Heritage Advisory Committee
March 27, 2013

DATE: March 8, 2013

SUBJECT: **Case H00371: Substantial Alteration 1259 Barrington Street (William Esson House), Halifax**

SITE PLAN

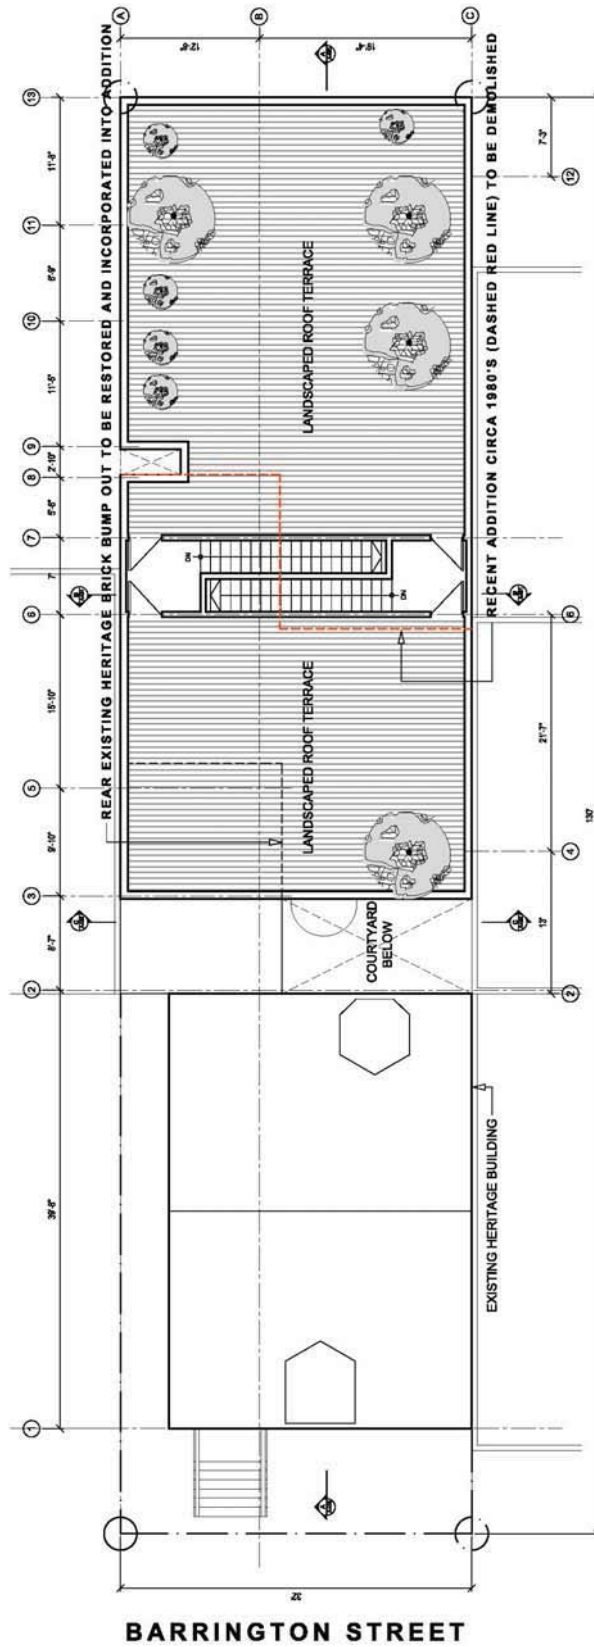
The proposed development involves changes to the rear of the William Esson House through the construction of a new four-storey addition containing seven units as shown in Attachment A. The proposed addition will connect to the William Esson House by an enclosed stairwell extending from street grade to a landscaped terrace on the roof of the proposed addition. The proposed addition will replace a prior two-storey addition and deck built in 1988 (Attachment D). It will incorporate an historic rear ell made of red brick and parking underneath the structure. For the most part, the addition will not be visible from any street with the exception of a portion of the enclosed stairwell, at the rear of the alleyway between the subject property and the neighbouring property to the north that will be visible from Barrington Street.

PROPOSED FRONT (WEST) ELEVATION AND REAR (EAST) ELEVATION

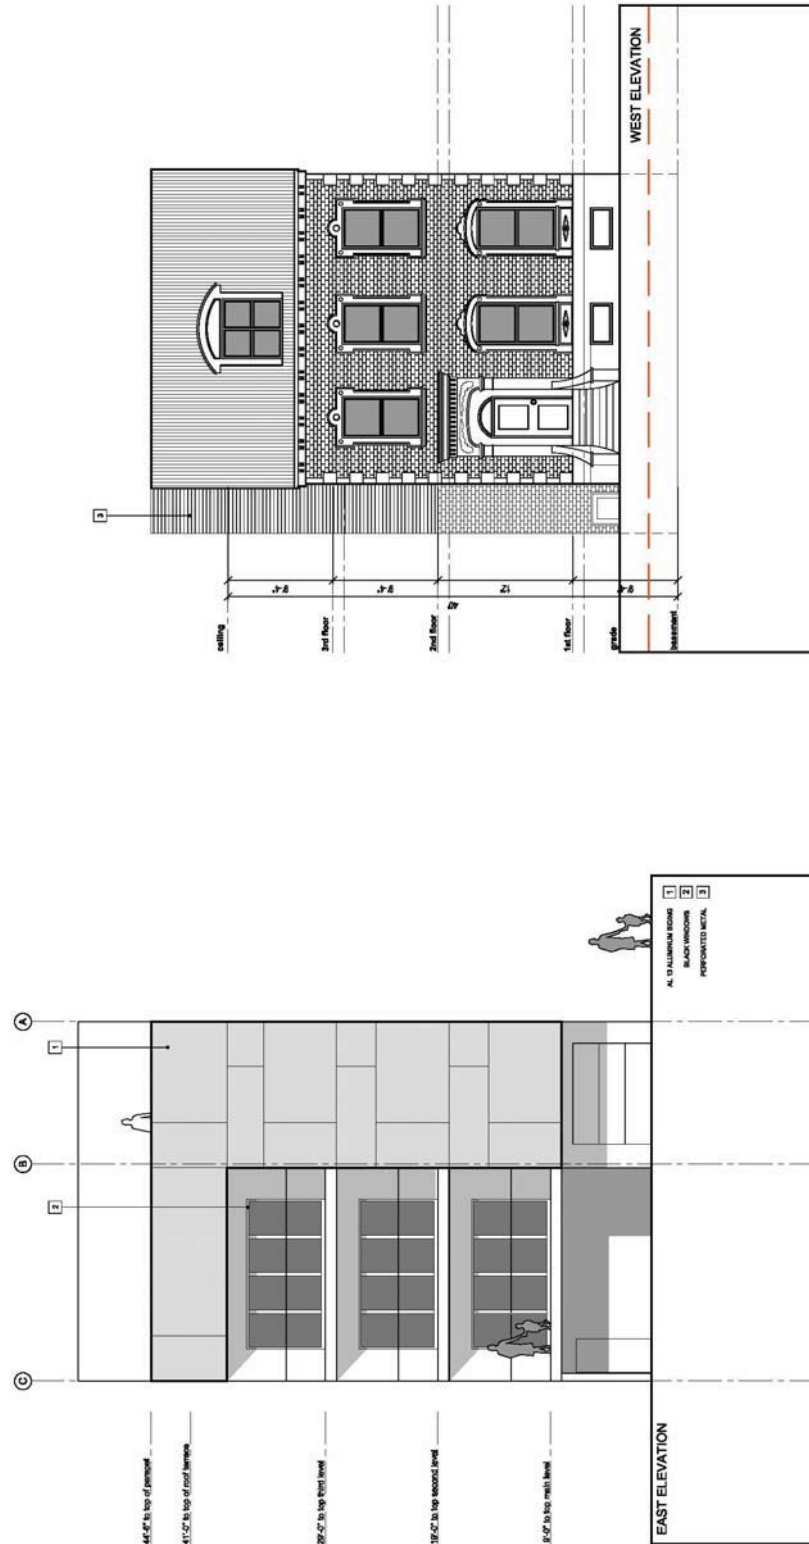
- **Historic Character:** The proposed addition is to the rear of the heritage building. It will result in minimal change to the character defining elements of the heritage building that are predominantly located on the front façade. One window at the rear of the heritage building will be converted into a doorway and enclosed by a stairwell. The dimensions of the opening will be changed to accommodate the doorway. This window is less distinctive than the windows on the front façade with little ornamentation. The enclosed stairwell may also necessitate an alteration to the modest roof overhang, by removing some roof material, at the rear of the building.

The proposed addition cannot be setback entirely from the building; it will be connected to the existing building by an enclosed stairwell which will be constructed on top of a rear ell original to the building. An outdoor terrace will replace the existing 1988 addition that is now in disrepair. The addition will also place the bulk of the new addition back from the existing building while providing communal space for the tenants. This terrace will also expose the rehabilitated red brick façade on the south side of the original rear ell while clearly distinguishing the heritage building from the new modern addition.

The proposed addition will be clearly distinguished as a modern building. The applicant indicates that the materials chosen for the proposed addition are high quality, durable, and require little maintenance. The proposed addition will be clad primarily with a durable aluminium wall panel with concealed fasteners as the primary material. All residential units will include ten-foot wide glass sliding doors to access balcony terraces. The enclosed stairwell connecting the heritage building to the modern addition will be clad in galvanized perforated metal that is partially transparent.

PROPOSED SIDE (SOUTH) ELEVATION

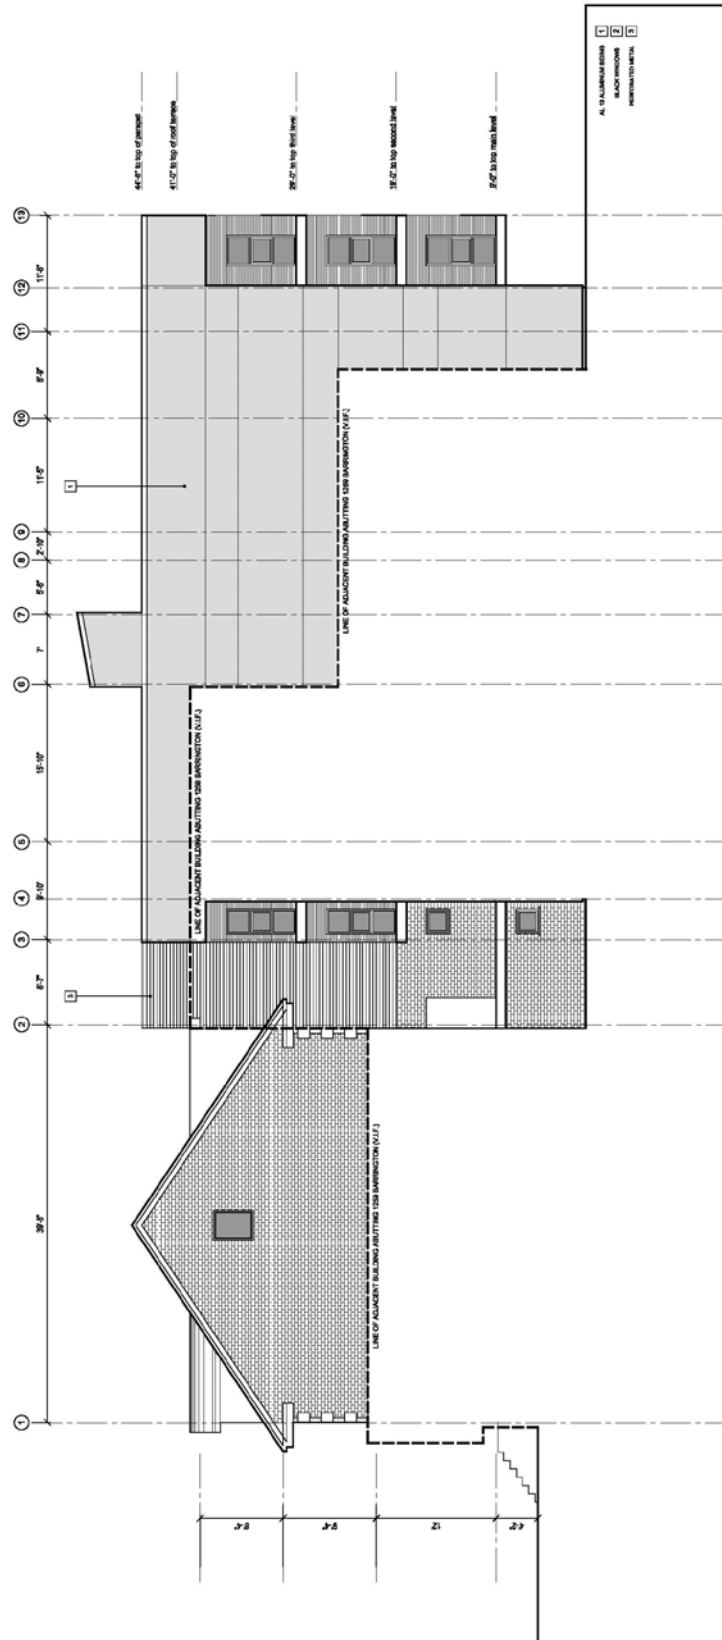
- **Integrity of Original Structure:** An original rear ell, constructed of red brick, will be largely preserved and rehabilitated as part of the new addition. A tall, red brick chimney, associated with the ell, will be removed. The red brick material from the chimney will be

Figure 3: Rear window to be altered and red brick chimney to be removed from the original rear ell

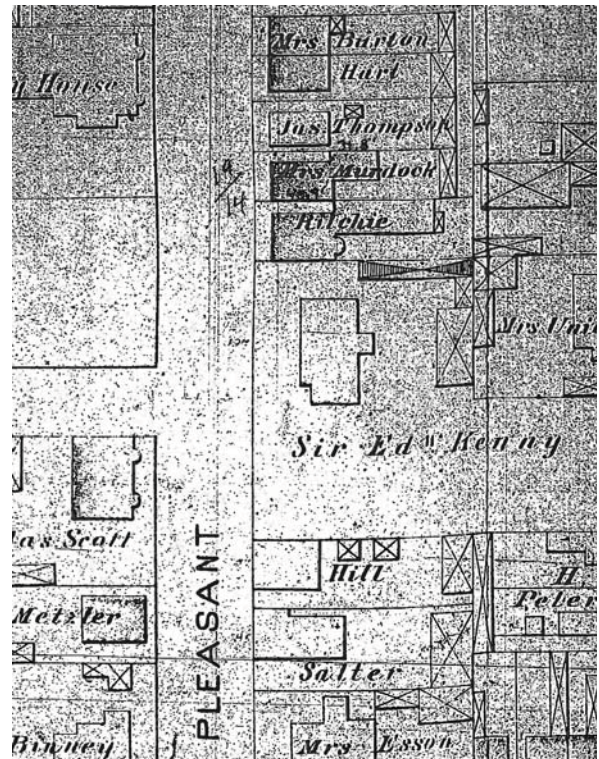
reused to rehabilitate the walls of the rear ell.
